In re: K269GG, Austin, TX  
BMPFT-20161031AEQ  
Facility ID No. 148525

This refers to the above-captioned minor change application.

Overlap Attachment:

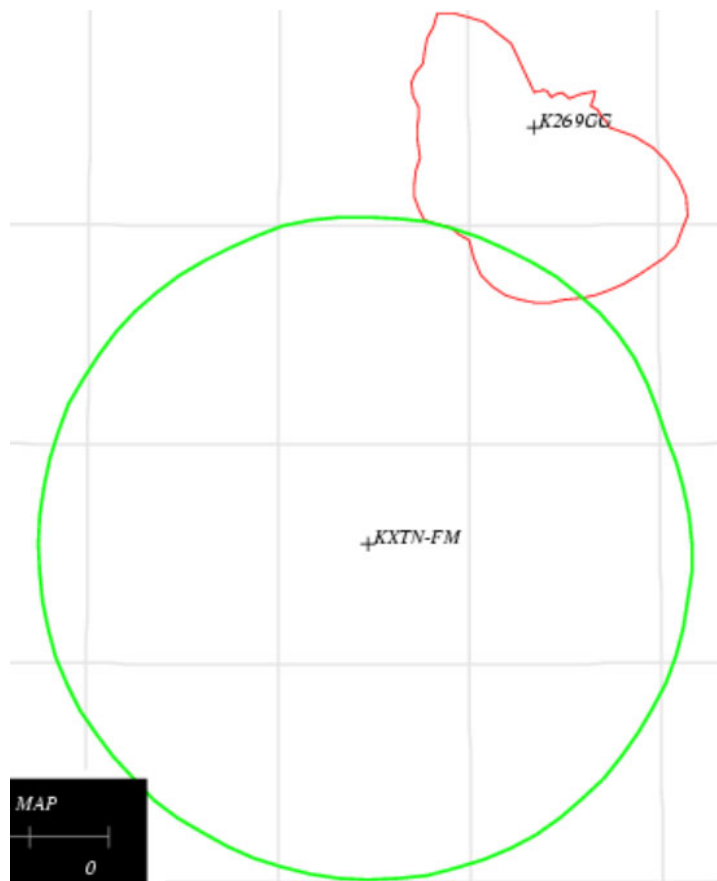
An engineering study reveals the application is in violation of the interference protection requirements of 47 C.F.R. Section 74.1204. Specifically, the proposed 40 dBu interfering contour overlaps the 60 dBu protected contour of the authorized facilities of co-channel station KXTN-FM, San Antonio, Texas (BLH-20060612AAY). The application does not recognize this defect. Accordingly, we dismiss the application as unacceptable for filing.

In light of the above, application BMPFT-20161031AEQ is unacceptable for filing pursuant to 47 C.F.R. § 73.3566(a) and IS HEREBY DISMISSED. This action is taken pursuant to 47 C.F.R. § 0.283.
